City of Lakewood  
Board of Building Standards •  
Architectural Board of Review •  
Sign Review Board

MINUTES  
BOARD OF BUILDING STANDARDS/  
ARCHITECTURAL BOARD OF REVIEW/SIGN REVIEW  
REVIEW MEETING  
CITY OF LAKEWOOD  
12650 DETROIT AVENUE  
AUDITORIUM  
AUGUST 14, 2025  
5:30 P.M.  
MEETING RECORDED  
<https://www.lakewoodoh.gov/videos-2/>

**Docket No. 03-21-25 (15431 Edgewater)**

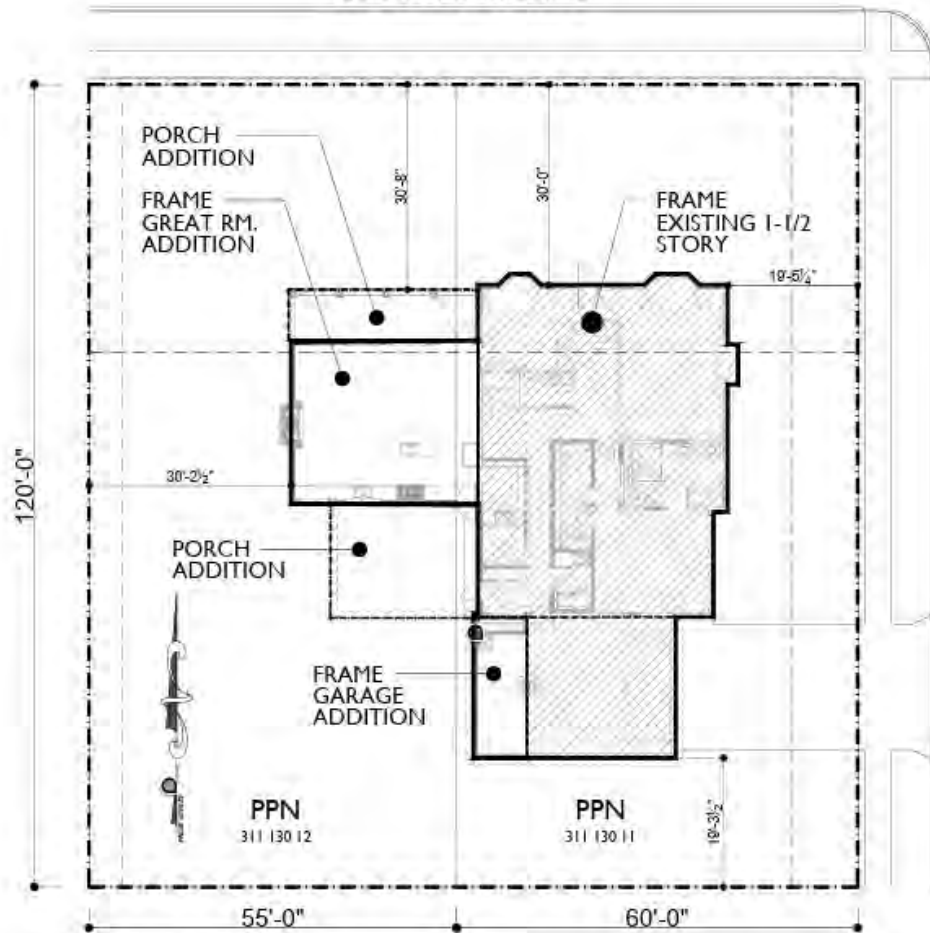
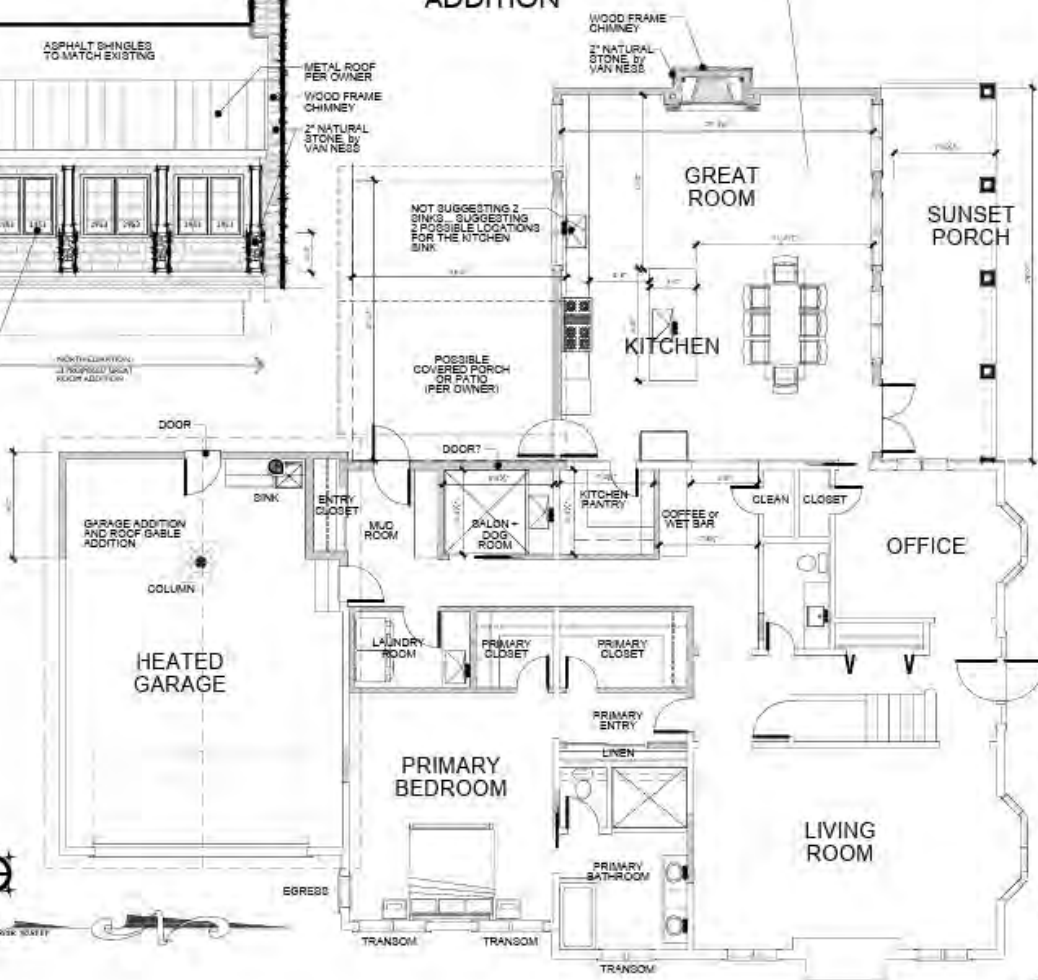
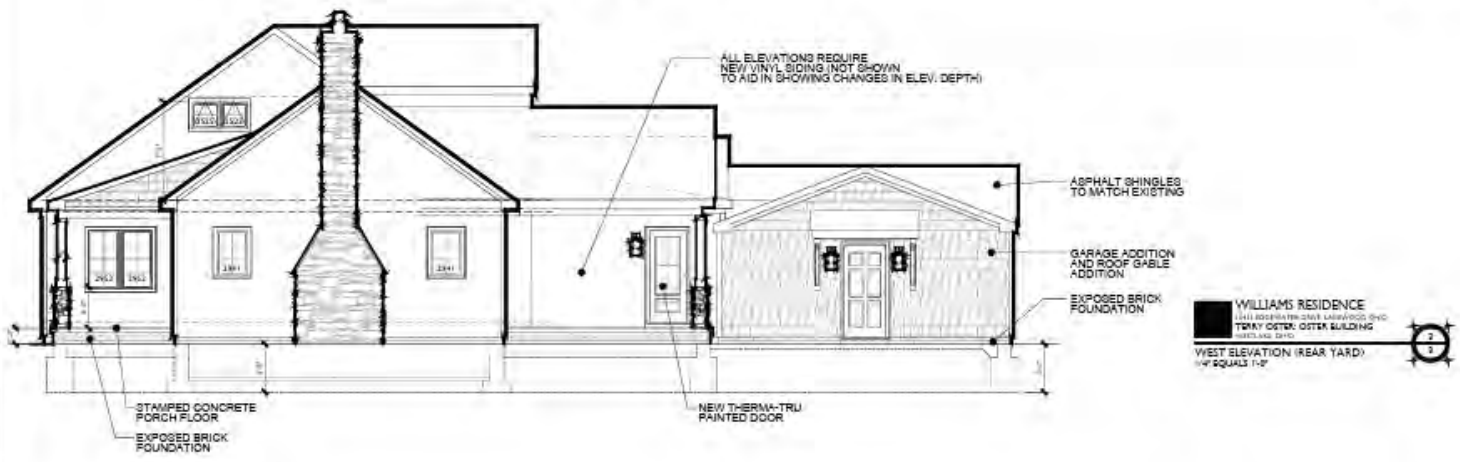
Mark Reinhold, applicant was present to explain the request. He noted the addition of dormers and front porch. He stated a metal porch would be an accent feature over the porch and that new window bays would fit under the existing eaves.

A motion was made by Ms. Cohan Plessner, seconded by Mr. Slaughterbeck to **APPROVE** Docket No. 03-21-25 as presented. All the members voted yea; the motion passed.

**Docket No. 08-62-25 (13611 Detroit)**

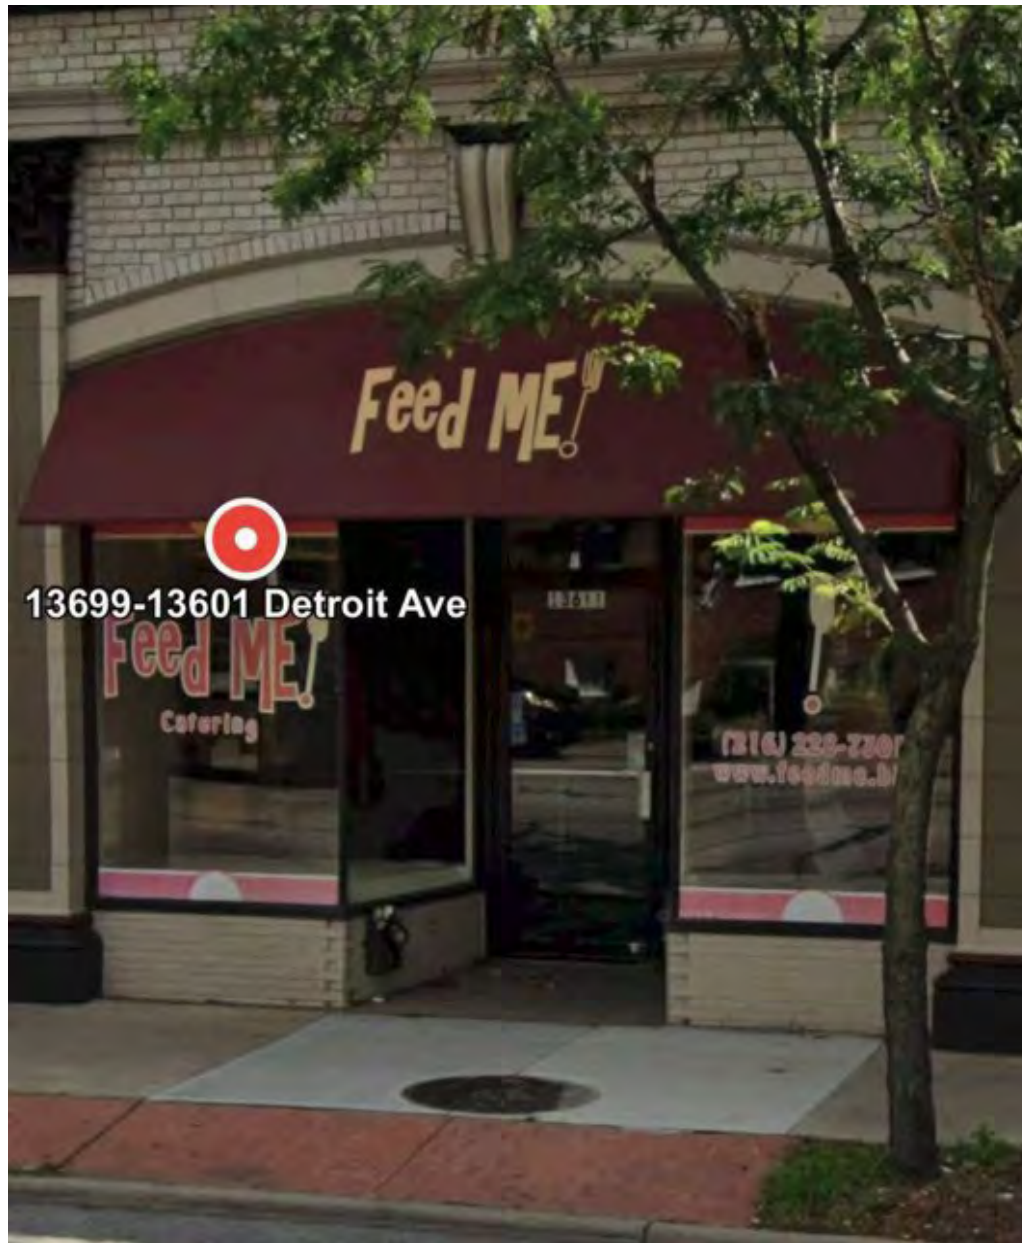
Ms. Cramer noted that neither the applicant nor a representative was present to explain the request, and that the members were allowed to render a decision, as per legal counsel. The proposal was over allowable square footage by a little. Removal of the QR code and one of the two telephone numbers would result in square footage allowance. Discussion continued with signage in the recessed door area and the frosted portion of the windows. Staff had no comments. Public comment was closed as no one addressed the item.

- Remove the QR code.
- Remove any signage in the recessed door area.
- The windows will not be frosted.

**Docket No. 08-67-25 (15901 Hilliard)**

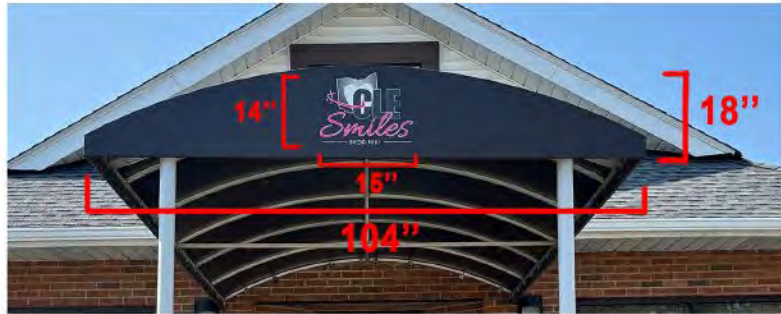
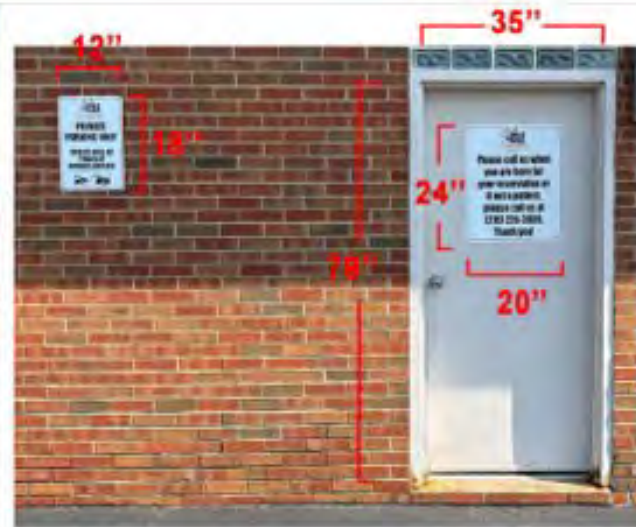
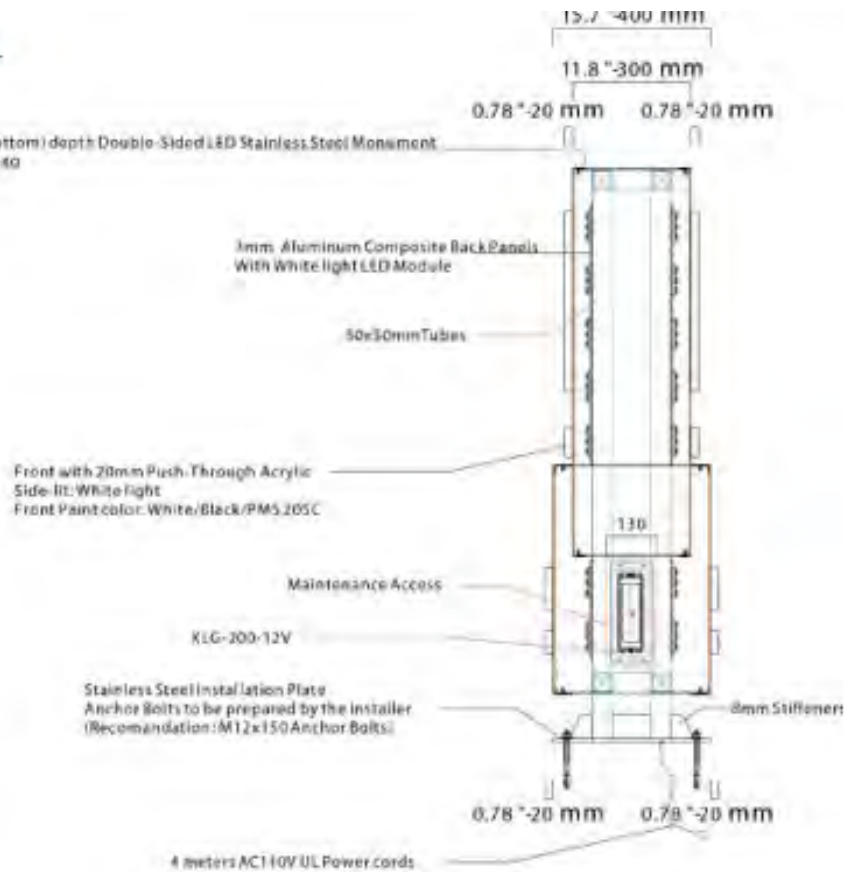
Kathy Clarke, representative was present to explain the updated request. Discussion revealed the window signage was over the allowable square footage; window vinyl graphics (removal of one of them), monument dimensions, and added landscaping. Public comment was closed as no one addressed the item.

- Remove the "6 month Smile" sign from the front window.

**Docket No. 08-68-25 (17510 Detroit)**

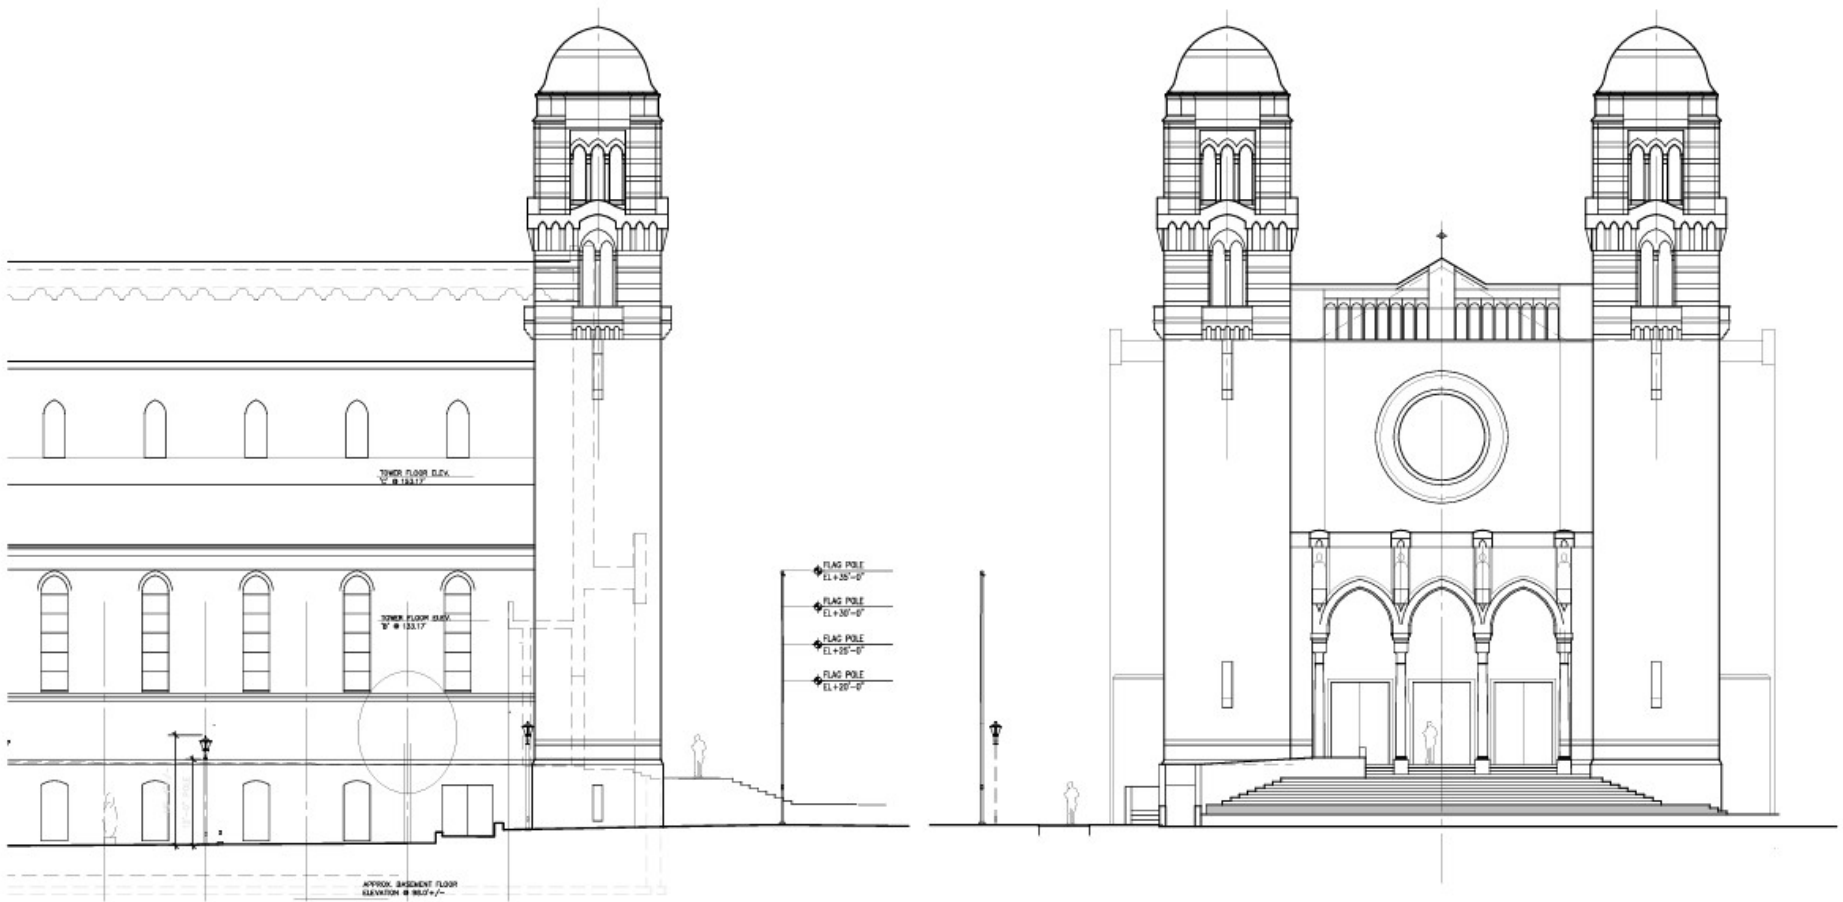
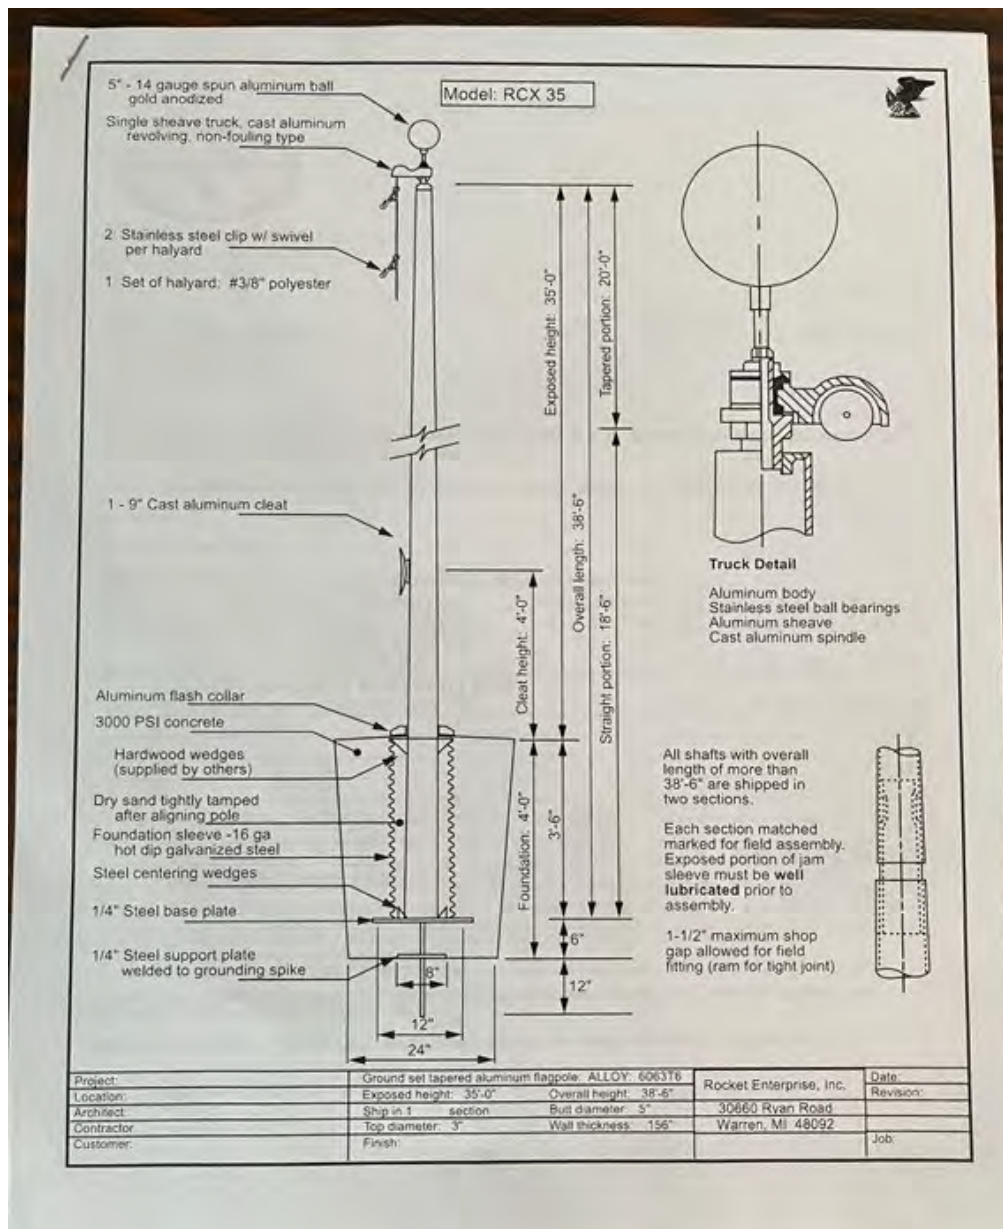
James McGinty, applicant was present to explain the request. The members were impressed with the applicant's preparation and said the proposal was appropriate. Ms. Cramer stated that the lighting at the base of the flagpole would be approved administratively. Public comment was closed as no one addressed the item.

- The ground uplighting is submitted for administrative approval.

**Docket No. 08-69-25 (15711 Madison)**

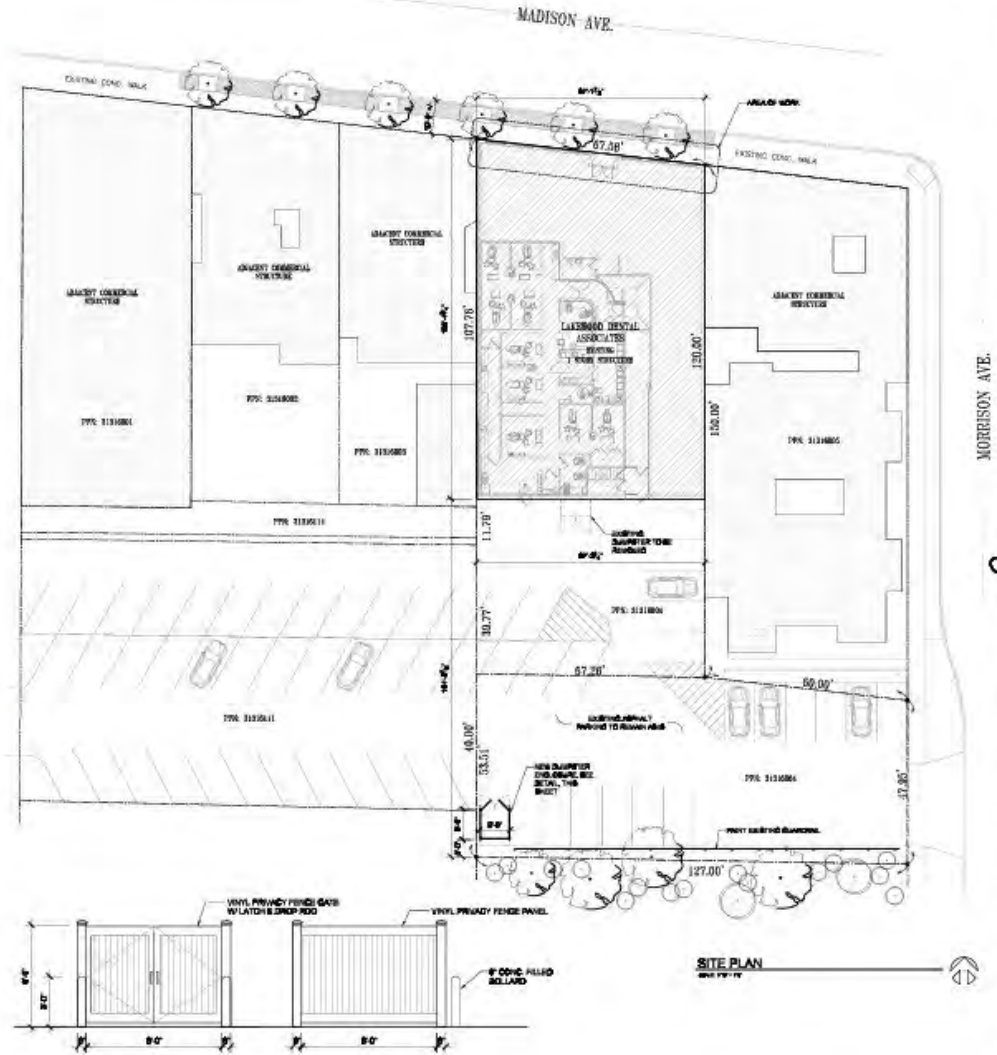
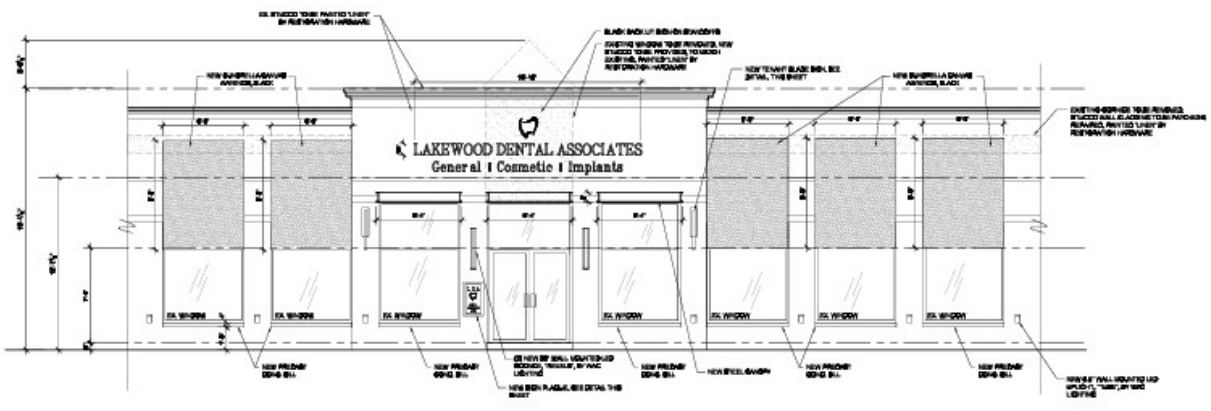
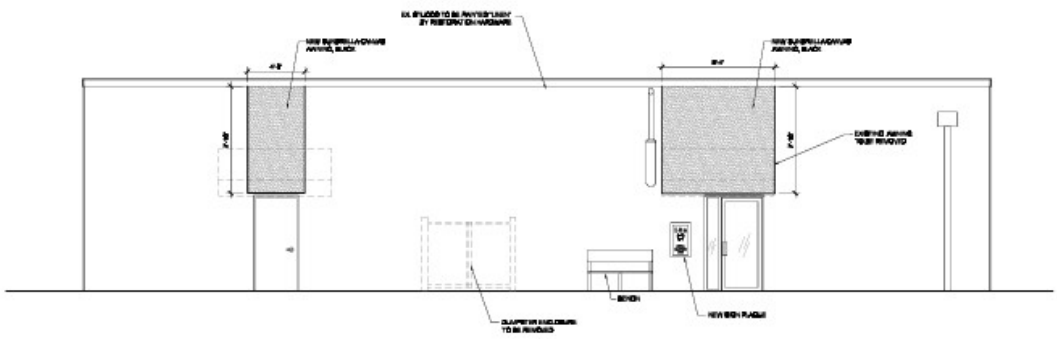
Leon S. Sampat, LS Architects Inc., applicant was present to explain the request. The members liked the proposal. Colors and materials were discussed, asked about the dumpster relocation and enclosure. Ms. Cramer said the property was eligible for a Commercial Storefront Renovation rebate. Public comment was closed as no one addressed the item. A comment received prior to the meeting was read into public.

- Signage is not included in this approval.
